NOTICE OF MEETING

TO: Planning Commission
FROM: Ken Roberts, Planning Director
AGENDA ITEM: **Goldridge Group PUD Concept Plan (Hudson Boulevard and Julia Avenue)**
REVIEWED BY: Ken Roberts, Planning Director
Sarah Sonsalla, City Attorney
Ben Prchal, City Planner
Jack Griffin, City Engineer

Lake Elmo Apartments (Goldridge Group) Concept Site Plan Review

SITE PLAN

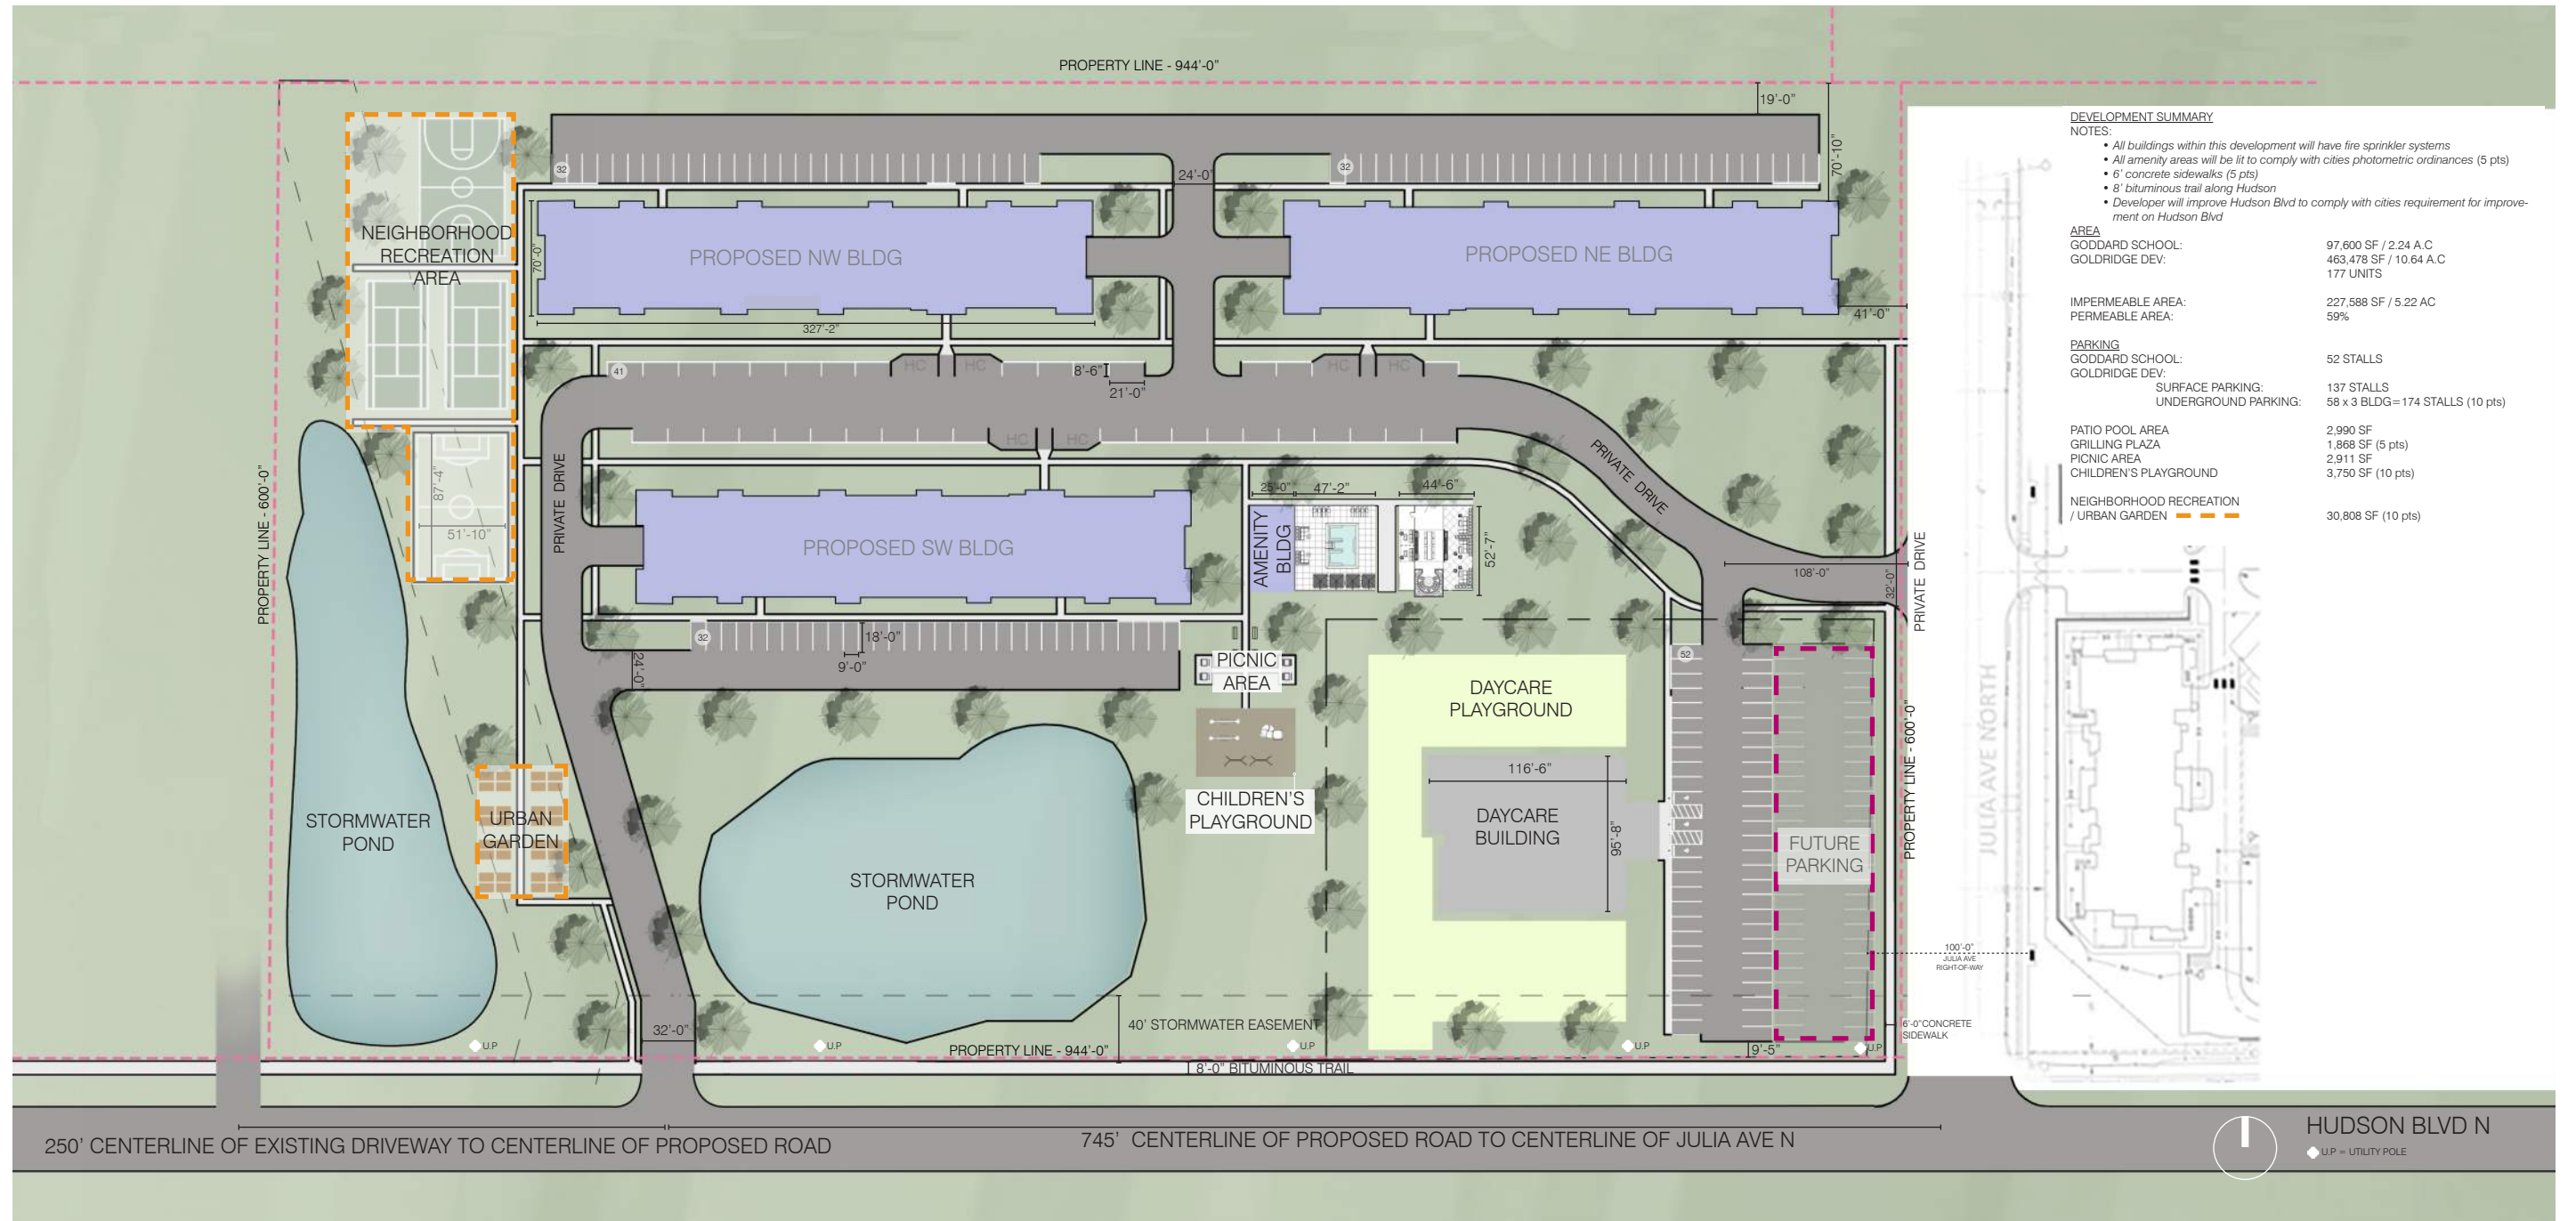
- Julia Avenue Right-of-Way Dedication. Additional right-of-way must be dedicated to the City to provide a minimum 100-foot right-of-way along the full length of Julia Avenue. In addition, a 10-foot dedicated utility easement must be provided directly adjacent to the 100-foot Julia Avenue right-of-way. The Concept plan appears to show the Daycare parking lot encroaching the Julia Avenue right-of-way. This must be revised as part of any preliminary plat submittal.

- Site Access. The concept plan proposes two new access locations for the development; one along Hudson Boulevard and one along Julia Avenue.
 - The proposed Hudson Boulevard access is shown to be located approximately 250 feet east of the existing Gatsby property, and approximately 750 feet west of the intersection with Julia Avenue. This access location is consistent with the Hudson Boulevard design requirements. Intersection and turning movement details must be provided with any preliminary plat submittal.

- Trail Connectivity. The City should review the site plan to determine trail connection requirements along Hudson Boulevard and Julia Avenue.
- Private Streets. The streets interior to the development are proposed to remain privately owned and maintained. Interior street design may require revisions to provide adequate fire lanes and safety access. The preliminary plat application must detail the private street typical sections, geometrics and proposed uses (e.g. parking) for further city review.
